# Technical Service Bulletin

**MODEL(S) AFFECTED: T500/T500e Walk-behind Scrubber**

**SUBJECT:** Potential drive wheel mounting hardware issue. The axle nut may back off and cause the wheel to become loose and possibly damage wheel and axle.

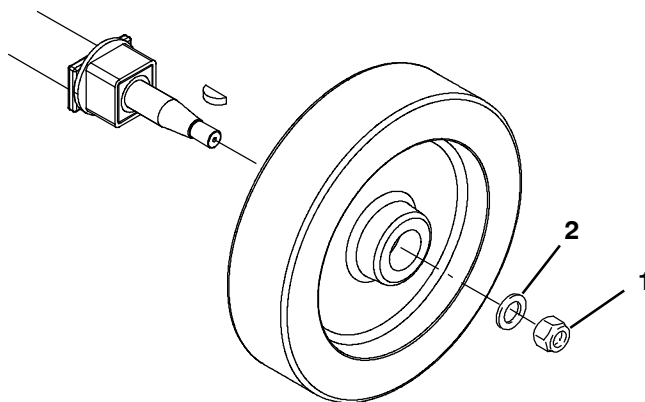
**PURPOSE:** To prevent axle nut from backing off, install improved hardware listed below.

Ref.	Part No.	Description
1	09741	Nut, Hex, Lock, M12 x 1.75, NL, SS
2	140058	Washer, Flat, 0.54b 0.88d .06, SS

Maximum torque 24 Nm/18 ft-lbs. Do not over tighten nut. Higher torques will deform the center of the wheel, compromising the conical fit to the transaxle.
